Product Change Notification

Product Group: DR/Fri May 31, 2024/PCN-DR-00005-2024-REV-0

CMF Industrial CMF50, CMF55, CMF60, CMF65, CMF07, and CMF20.

DIMENSIONS in millimeters

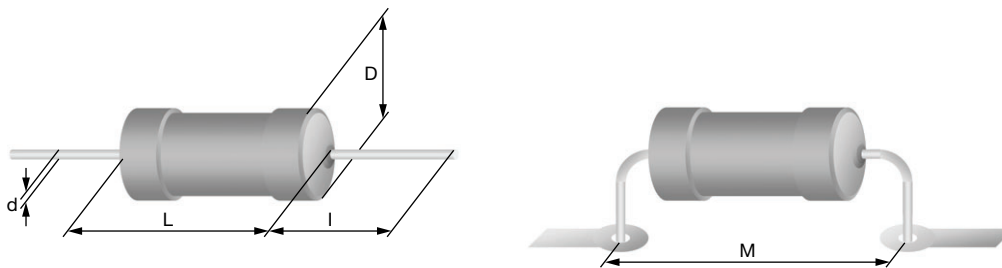
Description of Change: This only applies to the Industrial components only. Change of manufacturing location and component specifications. Changes may include, but are not limited to the following: Tolerances, Temperature, Values, TCR, Operating Voltages, Component Color, and mechanical specifications. All options will now only be lead (Pb) free. Please refer to the attached tables for changes and data sheet for specifications.

GLOBAL MODEL	D _{max.}	L _{max.}	d _{nom.}	I _{min.}	M _{min.}	MASS (mg)
CMF50	1.6	3.6	0.5	29	5	125
CMF55	2.5	6.5	0.6	28	10	220
CMF60	4.2	11.9	0.8	31	15	700
CMF07	2.5	6.5	0.6	28	10	220
CMF20	4.2	11.9	0.8	31	15	700

DERATING

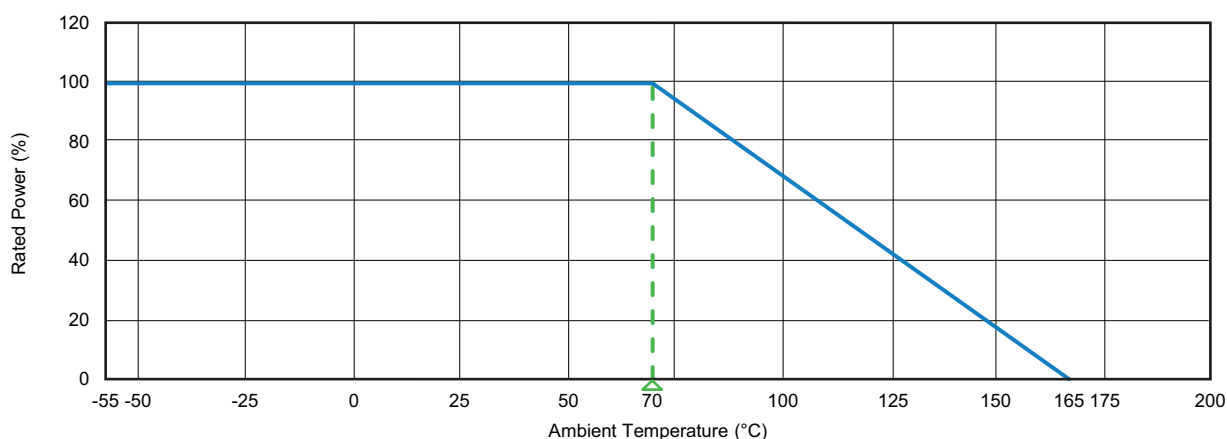
The power rating for the CMF parts is tied to the derating temperature, the heat rise of the parts, and the ΔR for the load life performance. When the tables/graphs below are used together they show that when the parts are run at their higher power ratings, the parts will run hotter, which has the potential of causing the resistance of the parts to shift more over the life of the part.

CMF resistors have an operating temperature range of -55 °C to +125 °C. They must be derated at high ambient temperatures according to the derating curve.
